Rezoning Application: RZ-PD 25-0147

**Hillsborough
County Florida**

Development Services Department

AGENCY REVIEW COMMENT SHEET

FIGURE 1
TYPICAL SECTION

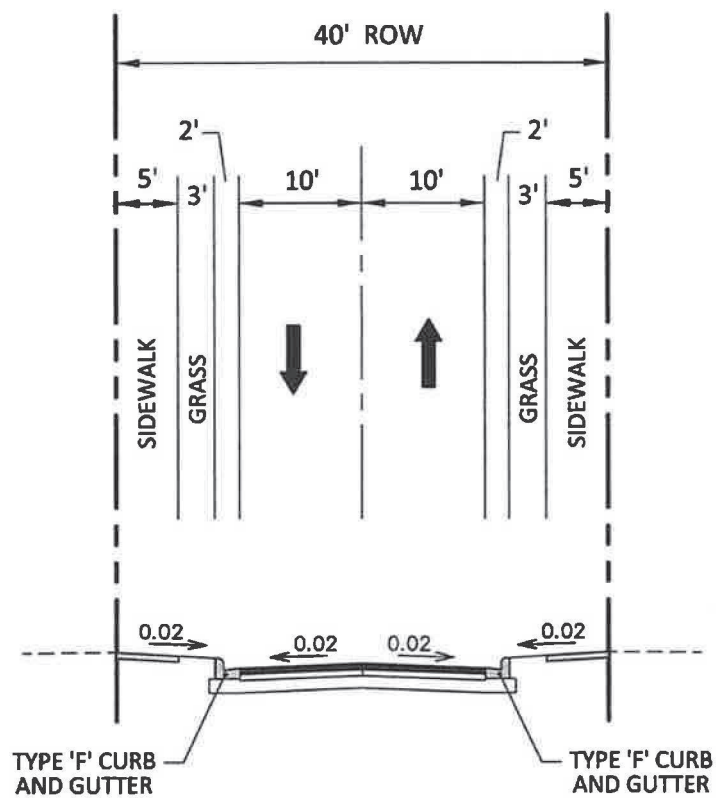
The request is for a Design Exception to TS-3 of the Hillsborough County Transportation Technical Manual for Colding Drive within the TECO property. The developer proposes to construct the subject segment of Colding Drive. The eastern approximately 330 feet of the proposed roadway traverses the TECO property in which there is only 40 feet of existing right of way. Therefore, a Design Exception is required to accommodate the roadway within the existing right of way. The following exceptions are requested to accommodate the proposed project.

- 1) Right of Way – TS-3 has 50 feet of right of way. The right of way within the TECO property is 40 feet.
- 2) TS-3 has 8 feet between the back of the curb and sidewalk. The proposed section reduces this to 3 feet.
- 3) Curb – TS-3 has Miami curb. Type F curb is proposed for the subject segment.

1. Due to limited right of way within the TECO property, the distance between the back of the curb and sidewalk was reduced.
2. To mitigate the reduction in the distance between the back of curb and sidewalk, Type F curb is proposed from west of the TECO property to 15th Street.

Figure 1 illustrates the proposed typical section and Figure 2 illustrates the limits of the proposed section.

_____ Disapproved
 X Approved

The County Engineer has reviewed zoning modification application # 25-0147 and determined the changes to be de minimis. As such, the previous approval shall stand.
